<b>Location:</b>	<b>5000 Piedmont Avenue (APN: 048A700200302)</b>
<b>Proposal:</b>	To construct a one-story, 8,500 square foot chapel, located near the southwest of the Mountain View Cemetery (approximately 400 feet from the main entry). Note: <i>This project was previously approved by the Planning Commission in 2013, but the Planning Permit (REV130001) had expired for the new construction. Under the new application (PLN16170), the applicant is requesting re-approval that includes minor building design modifications.</i>
<b>Applicant/Contact:</b>	Jeff Lindeman
<b>Phone Number:</b>	(510) 658-2588
<b>Property Owner:</b>	Mountain View Cemetery Association
<b>Case File Number:</b>	<b>PLN16170</b>
<b>Planning Permits Required:</b>	Major Variance to operate an undertaking activity (funeral services) in the RD-1 Zone; and Regular Design Review for new building construction.
<b>General Plan:</b>	Urban Open Space

# CITY OF OAKLAND PLANNING COMMISSION

Case File: PLN16170  
Applicant: Jeff Lindeman  
Address: 5000 Piedmont Avenue  
Zone: RD-1

**Project Name: Water Pavilion - Reapproval of expired design review and variance permit.**

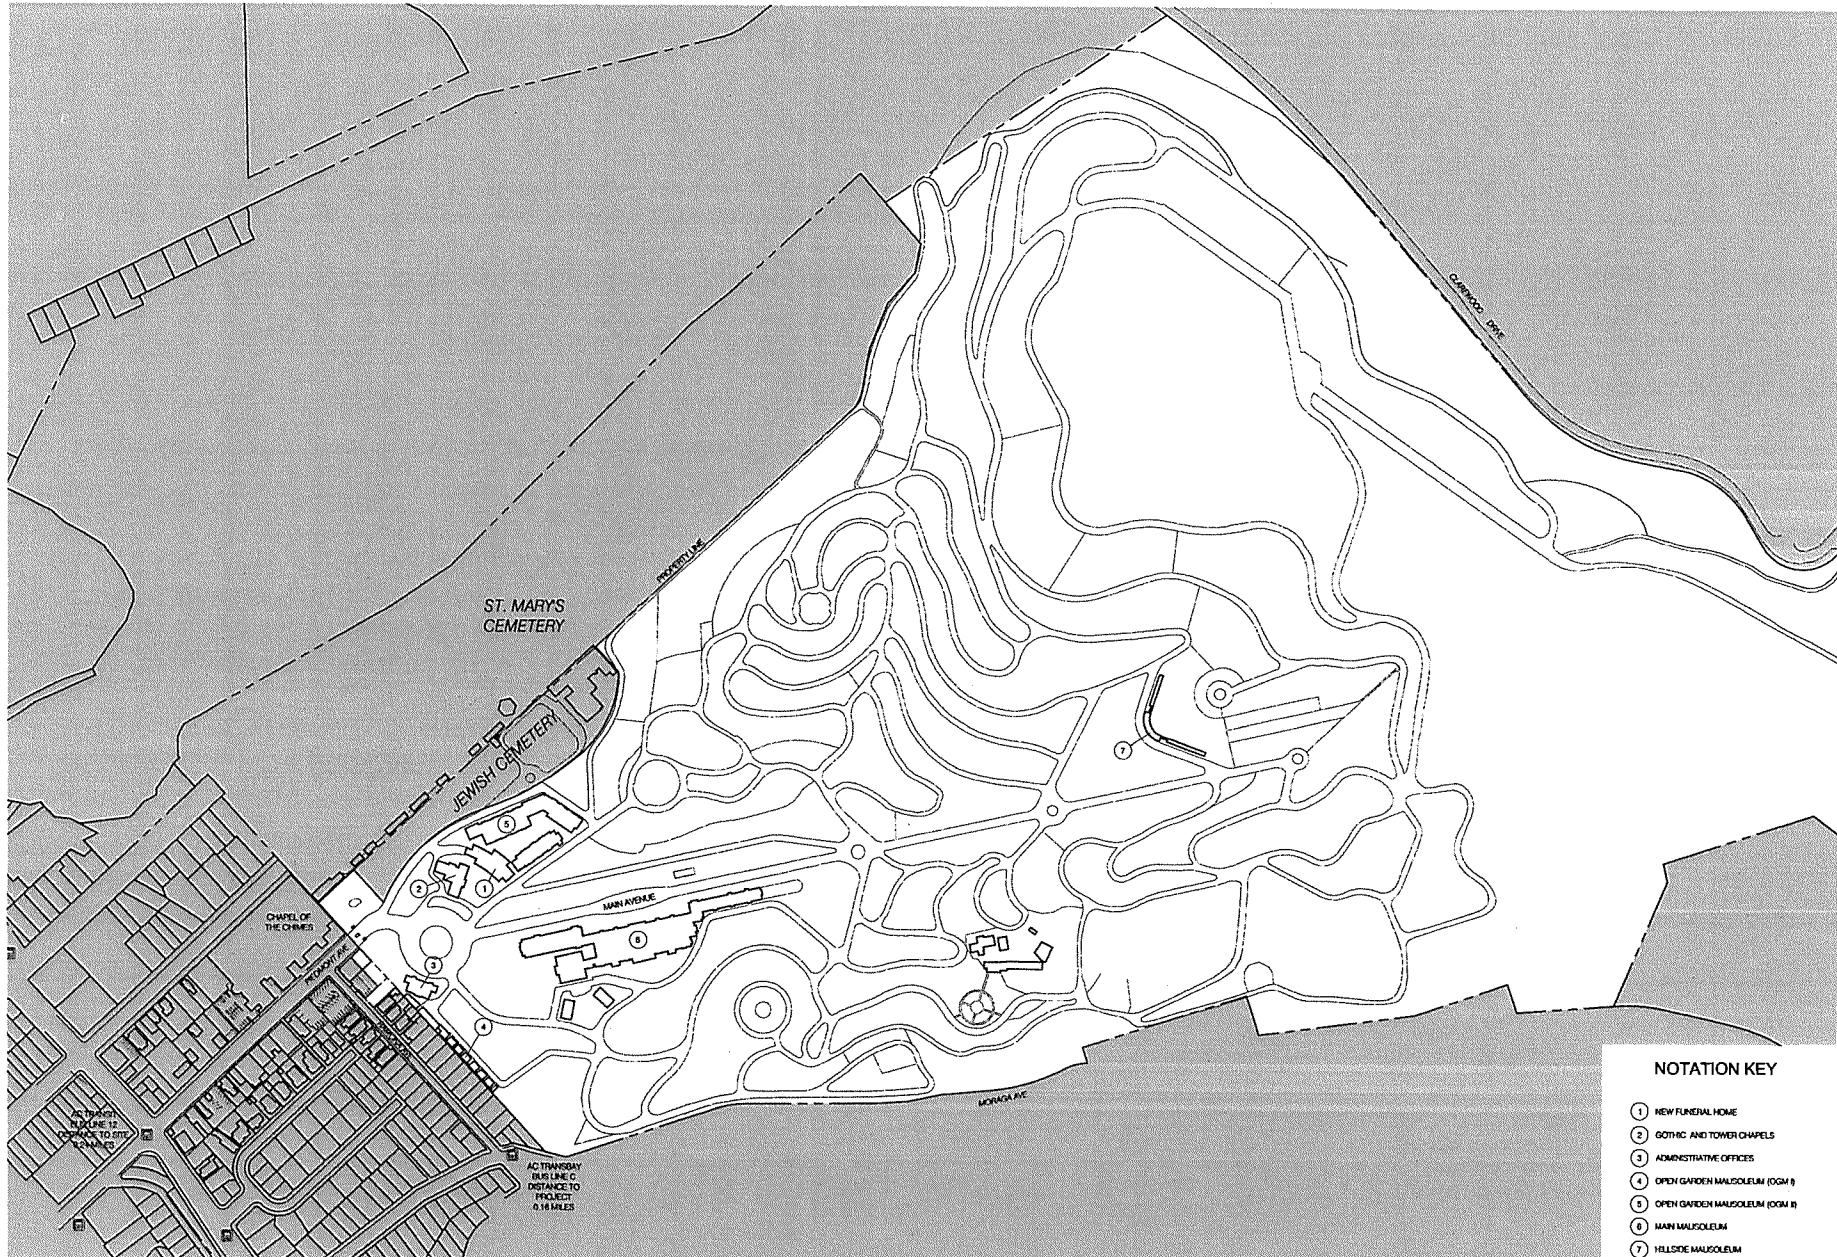
**Changing:**

- \* Code requires additional of a mechanical, electrical and plumbing plenum
- \* Chapel ceiling from a flat plaster ceiling to a series of barrel vaults
- \* Lighten fenestration for pond side doors; garden side fenestration to remain at 12' height but may require 10' doors and a 2' transom instead of 12' doors
- \* Stone cladding color palate remains unchanged, but finish will be a combination of honed and textured finish. Piece height remains at 24" but widths are reduced to a random pattern of widths.
- \* The west garden layout is made to be more curvilinear and fire place and water fall options are added to it.
- \* Clarification that chapel roof line overhangs the pond 8' to 10'

PROPOSED  
SITE PLAN

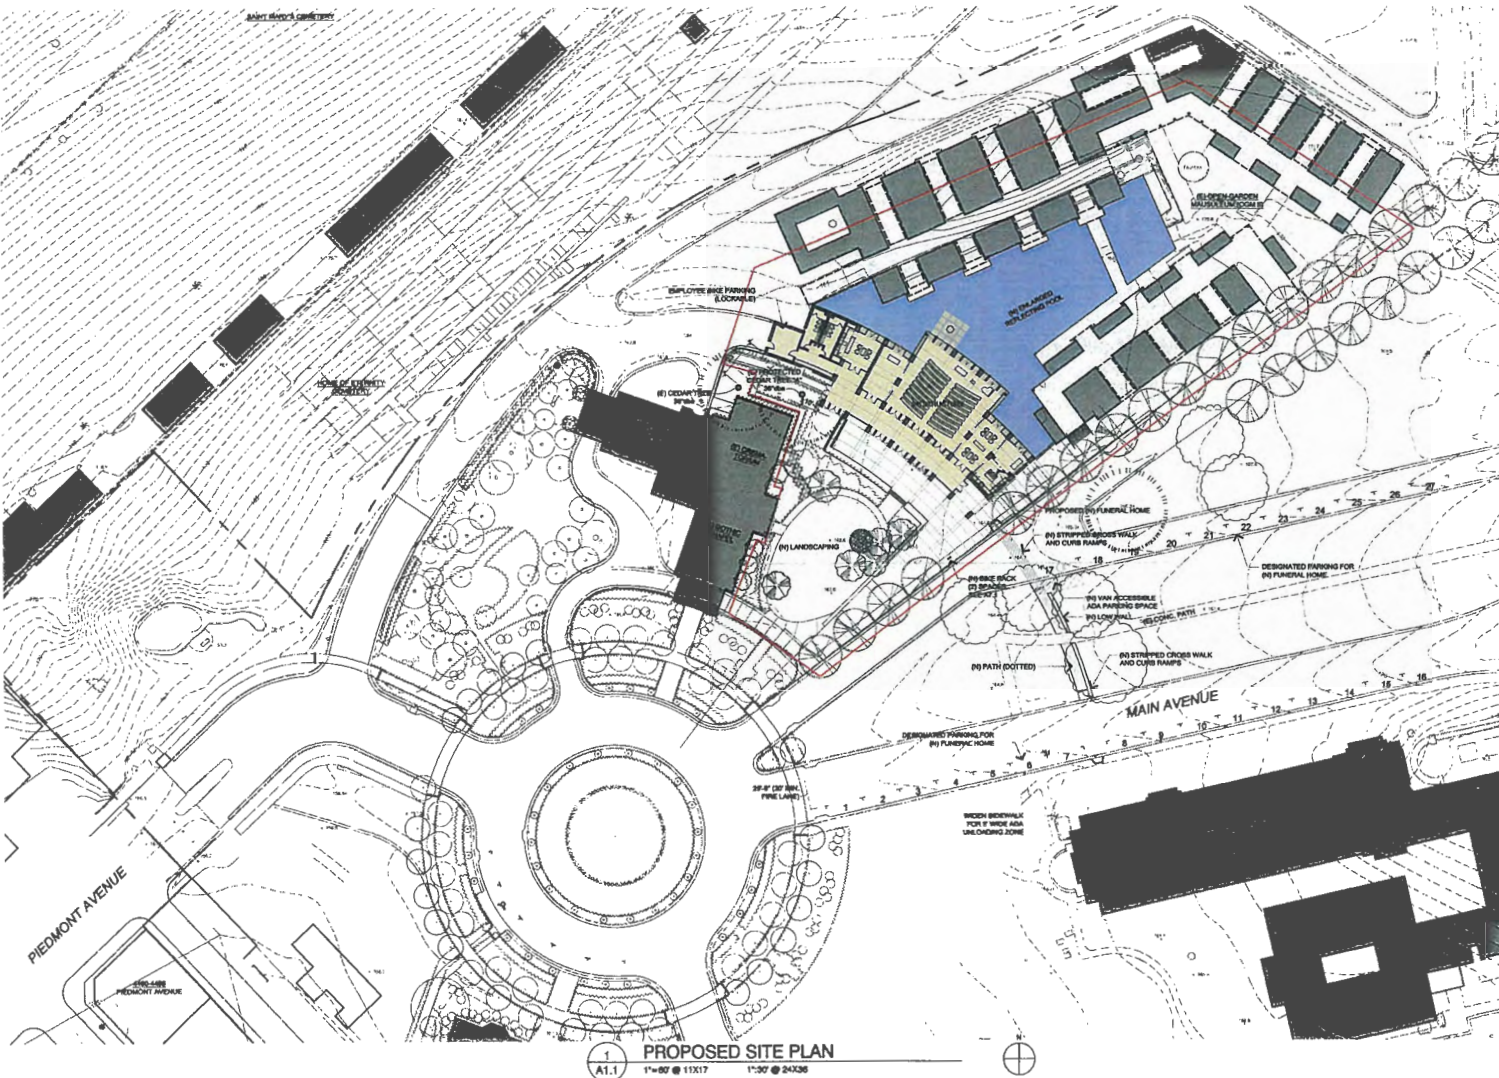
Key Changes:  
Site Plan- There are no changes to the locations of the pond, Water Pavilion building and patio or garden projects.

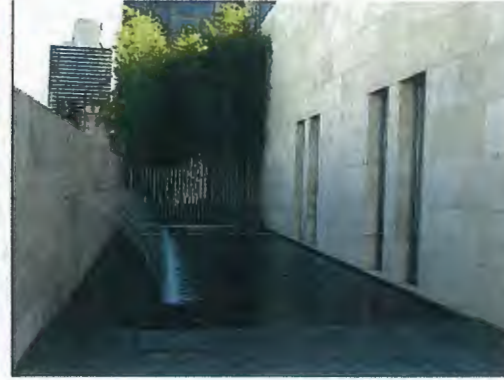
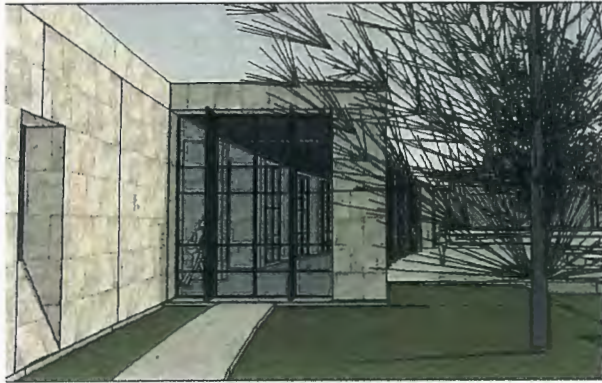
- 2016 Key changes:**
- \* Addition of a recessed 2' deep mechanical (HVAC), electrical, plumbing and sprinkler plenum (this is an interior addition and not an addition of visible mechanical equipment to the roof)
  - \* Addition of barrel vaults to chapel ceiling

2 PROPOSED SOUTH-EAST ELEVATION  
3/64"=1'-0" @ 11X17 3/32"=1'-0" @ 24X36

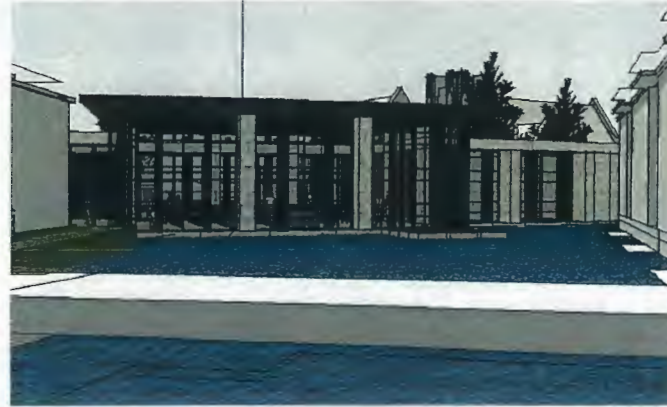
- 2016 Key changes:
- \* Stone cladding to be a smaller random tile of honed or textured limestone or travertine
  - \* Stone, honed finish- 2" to 3" depth, limestone or travertine, overhead at doorways

- Reasons:
- \* Cost inflation from 2013 to 2016
  - \* A smaller stone module is sympathetic to the curved shape of the building to avoid a faceted appearance
  - \* Larger blocks aesthetically conveys structure and ties to mass of large door frames

2016 Changes

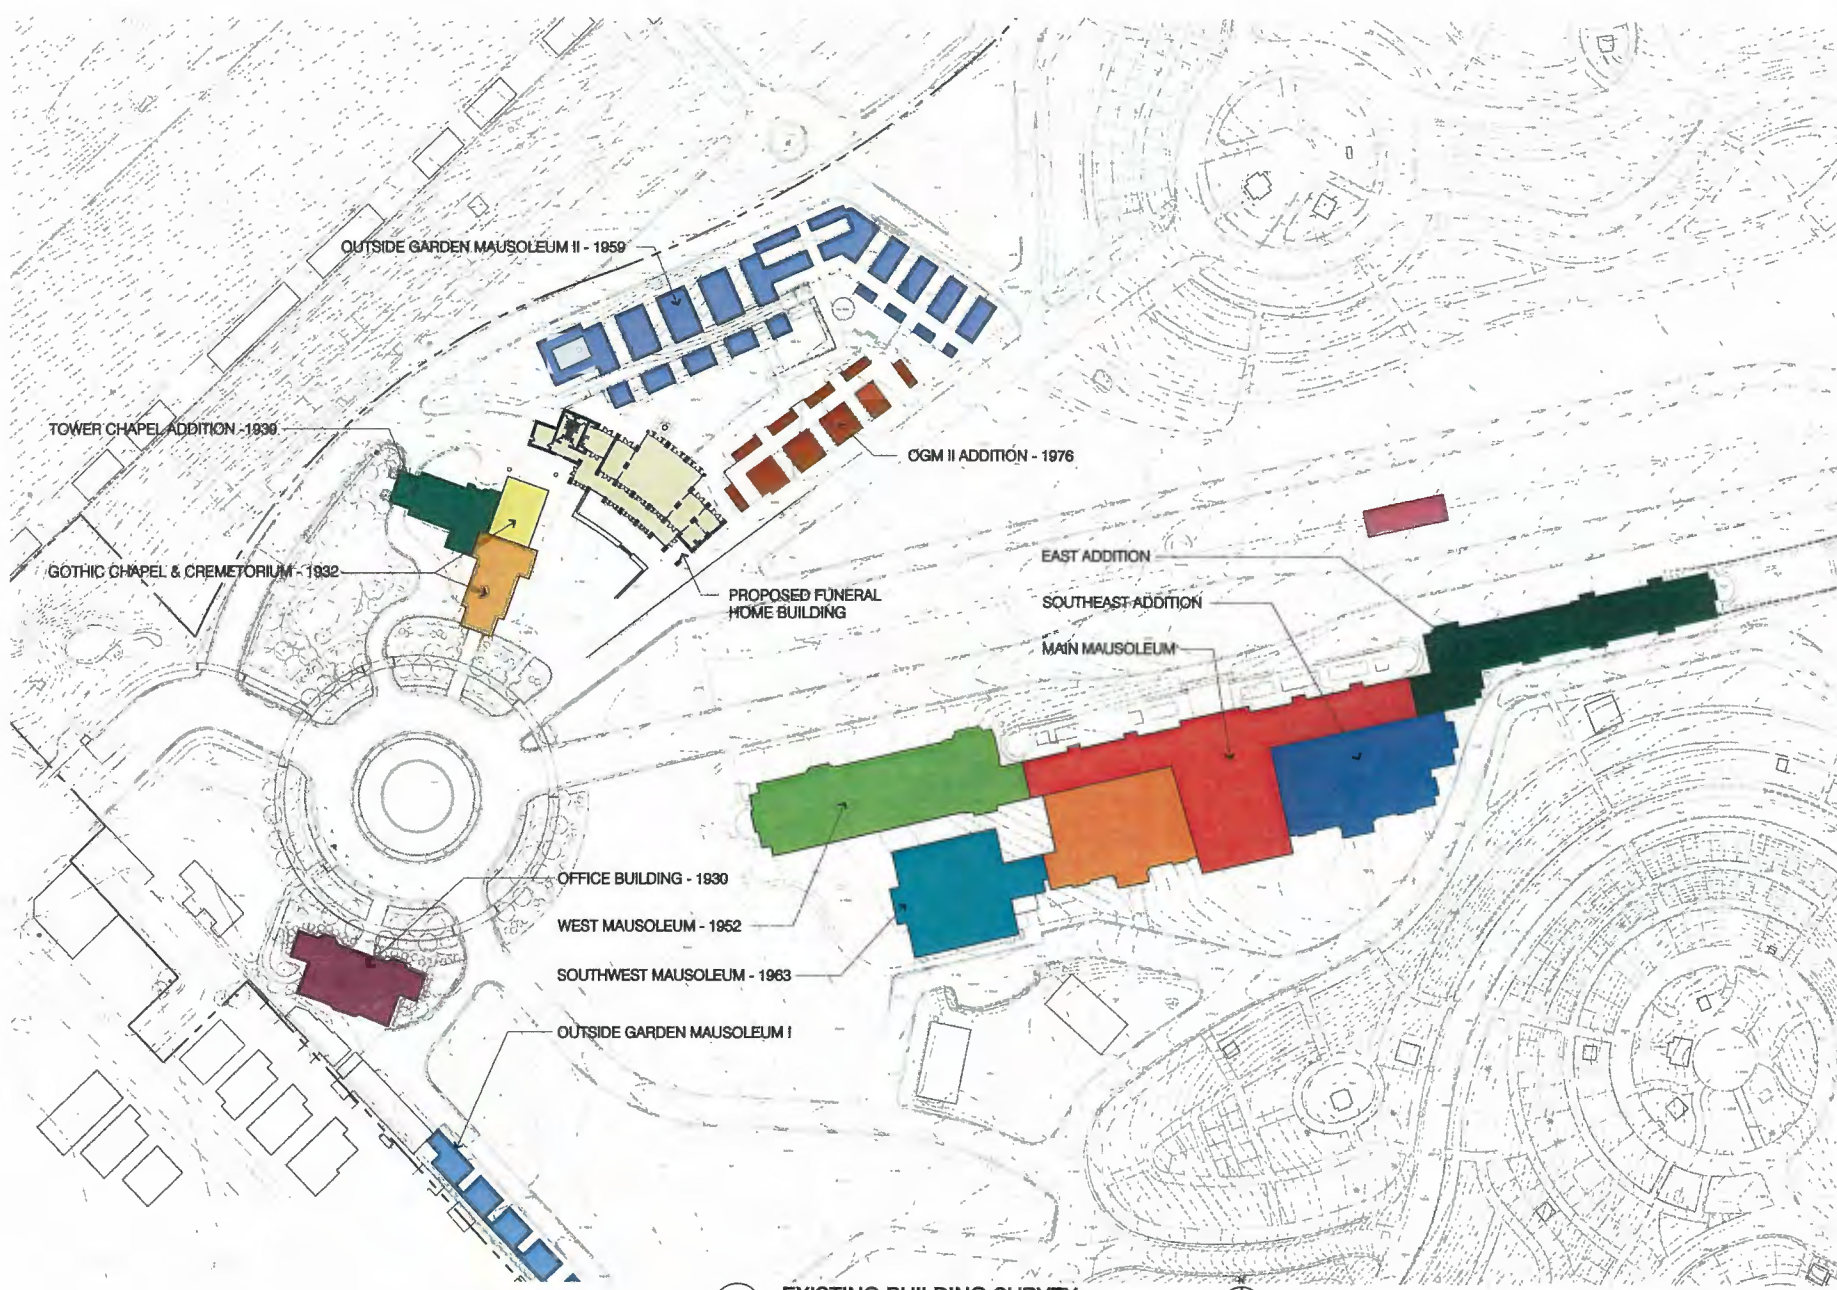
- \* Addition of a gas fire seating area as gathering focal point; draws visitors into the garden
- \* Curvilinear shape to make interesting nodes for sculpture and/ or ornamental trees; reduced turf maintenance shifts water use to shrubs and trees
- \* Water-fall from patio to garden enhances the visitor's experience with motion and sound and thematically ties patio and pond sides together
